NX 2.0.8800 / 3.0.8800	Type 4406/303	SB No. 06
DX-D 100	Type 5410	SB No. 41
DX-D 100 Wireless	Type 5411	SB No. 39
DX-D 300	Type 8207	SB No. 44
DX-D 400	Type 5420	SB No. 14
DX-D 500		SB No. 32
DX-D 600	Type 5430	SB No. 34
DX-D Retrofit	Type 5400	SB No. 15
DX-Si		SB No. 04
SE+NX		SB No. 08
		DD+DIS014.14E

Service Bulletin

Software update NX 2.0.8800 / 3.0.8800 SU1 available for CR and DR solutions

Figure 1

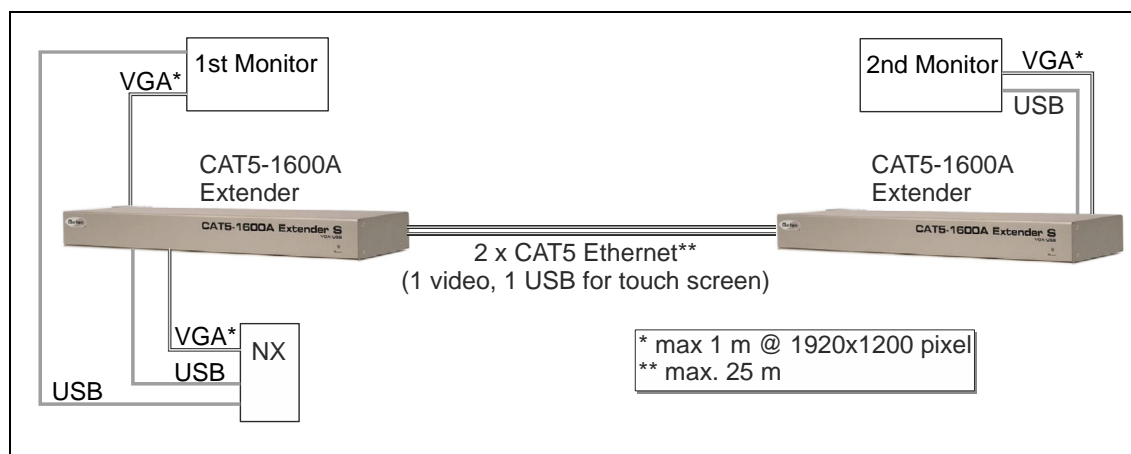
Both monitors need to be connected via Extender as shown in Figure 1. When connecting one monitor directly to NX, the 2nd monitor is working as an extension to the first monitor, but not as an exact copy.

Figure 2

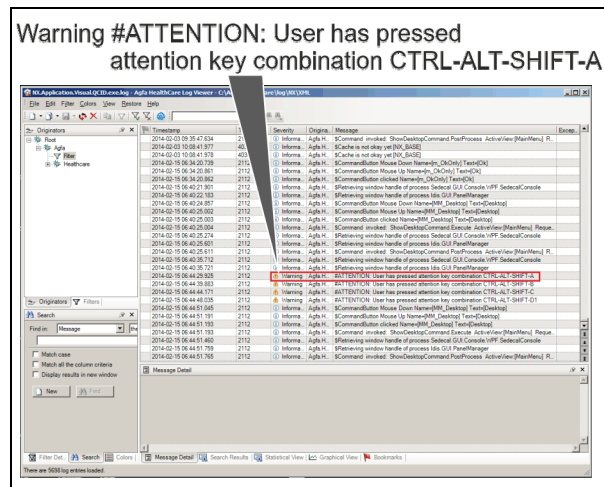
- NX Service Manual chapter "9 Troubleshooting" contains information about "Attention keys": This feature was already introduced with NX 2.0.8800 / 3.0.8800, to facilitate the analysis of field issues in case an issue can be reproduced in the field but not by R&D. Example: A certain error appears in the field during operation. Press "CTRL-ALT-SHIFT-A" to add following line to the NX log file: **Warning #ATTENTION: User has pressed attention key combination CTRL-ALT-SHIFT-A".**

If the same or a different error appears some times later, press e.g. "CTRL-ALT-SHIFT-B" to indicate the 2nd error. When passing the NX logfile to the RSN or GSN, inform about which attention key you pressed with which event.

Figure 3

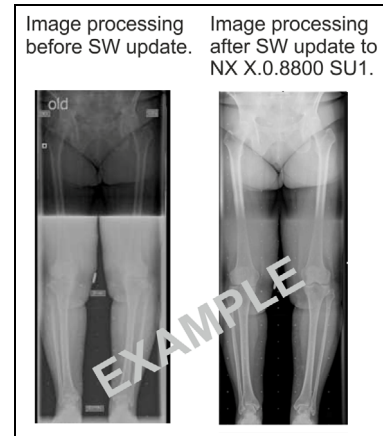
Symptom The stitched FLFS image shows strong density differences between single images, whereas the single images look ok.

Cause The average intensity of the partial images can vary depending on the imaged body parts (e.g. top image is chest and bottom image is abdomen). The exposure settings are different for this kind of exposures and the used dose can vary.
As a result the stitched image has sub regions with different average intensity. This intensity difference is preserved by the Musica2 processing and is visible in the "For Presentation" image.

Solution The image processing in software NX 2.0.8800 / 3.0.8800 SU1 improves the image appearance in case of large density differences at stitched FLFS images.

Figure 4

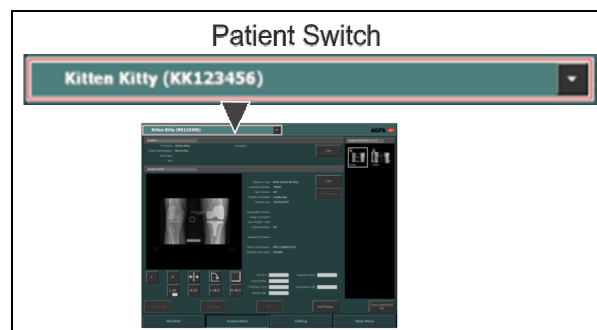
Symptom In a very unlikely sequence of user actions* when adding patient data manually and working at different exams simultaneously it is possible, that exam data might be mixed-up.

*Sequence of user actions: The user creates a manual session, enters all patient data, and optionally adds some exposures. Prior to end adding exposures the user switches to another already open session with the intention to start working on that session. Now the user could notice that the displayed patient data and exposure thumbnails are the same as the ones the user has just entered. If the user does not notice that the name in the patient switch is different from the one in the view patient pane, he may think he is working on the exam for the patient in the patient switch, while in reality he is working on the exam for the patient in the view patient pane.

Solution In NX 2.0.8800 / 3.0.8800 SU1 the patient switch is disabled after manual creation of a new session.
